SUBJECT: AMENDMENT NO. 137 TO PROVISIONAL OPERATING LICENSE NO. DPR-20:
(TAC NOS. 77576 AND 77670)

PALISADES AMEND 77576/77670

ATTACHMENT TO LICENSE AMENDMENT NO. 137

RELATING TO CYCLE 9 RELOAD

FIGURE 3-0
ASI LCO FOR Tinlet FUNCTION

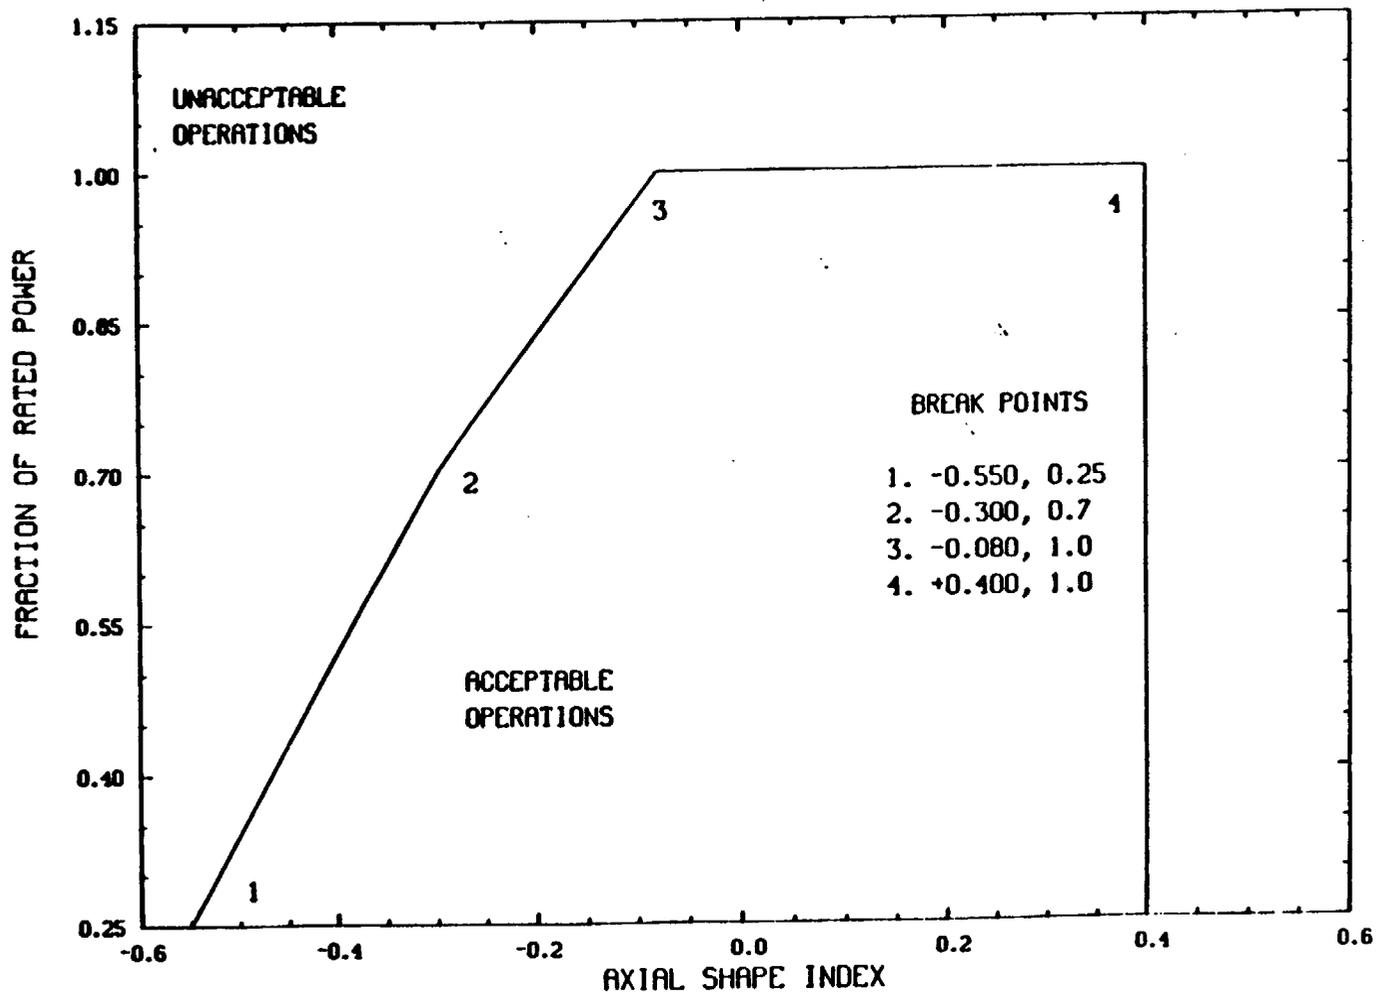
When the ASI exceeds the limits specified in Figure 3.0, within 15 minutes, initiate corrective actions to restore the ASI to the acceptable region. Restore the ASI to acceptable values within one hour or be at less than 70% of rated power within the following two hours.

The Axial Shape Index alarm channel is being used to monitor the ASI to ensure that the assumed axial power profiles used in the development of the inlet temperature LCO bound measured axial power profiles. The signal representing core power (Q) is the auctioneered higher of the neutron flux power and the Delta-T power. The measured ASI calculated from the excore detector signals and adjusted for shape annealing (Y_1) and the core power constitute an ordered pair (Q, Y_1). An alarm signal is activated before the ordered pair exceed the boundaries specified in Figure 3.0.
